CHATHAM COUNTY PURCHASING DEPARTMENT

ADDENDUM NO. 3 TO 11-7-4-4

FOR: Construction of the New Public Works and Park Services Facility

IRRIGATION

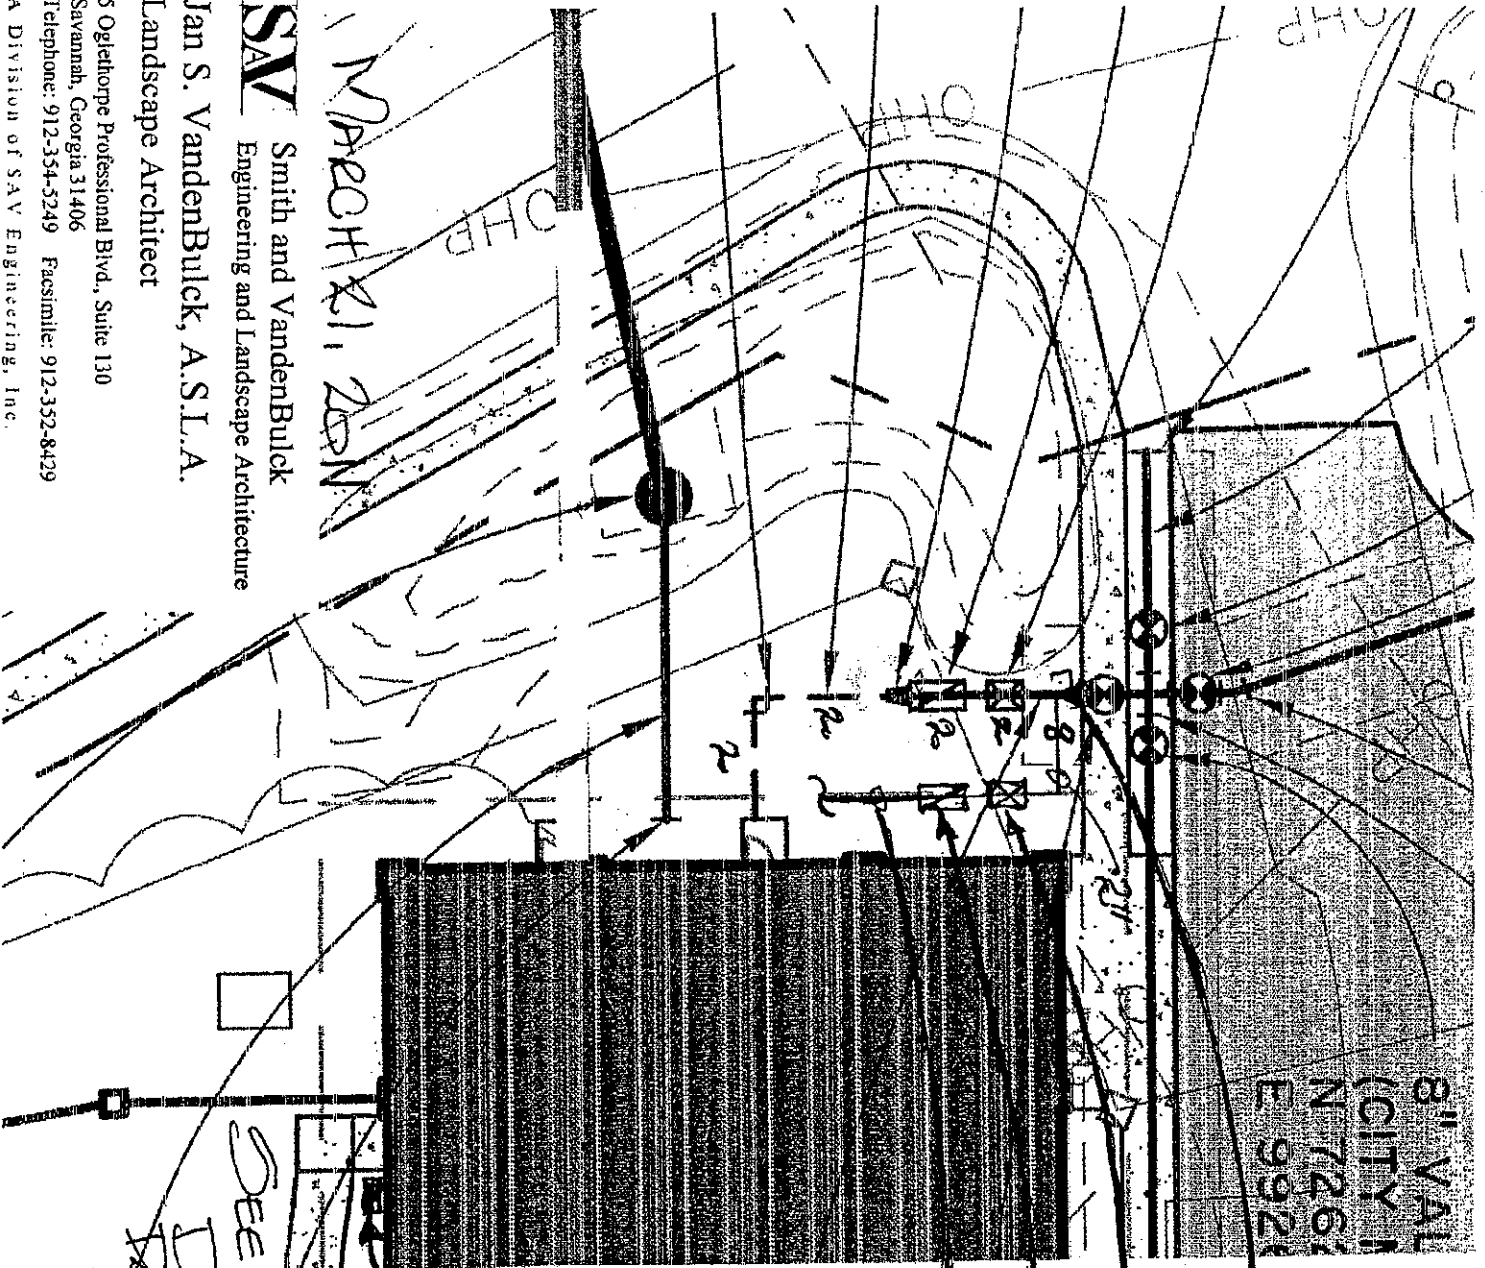
- d. All central steel shafts shall be hot-dipped galvanized.
5. Spec Section 02813: the contractor shall provide the design of the irrigation plan (to be reviewed and approved by the landscape designer). See attached sketch "Irrigation Information" for water supply diagram.
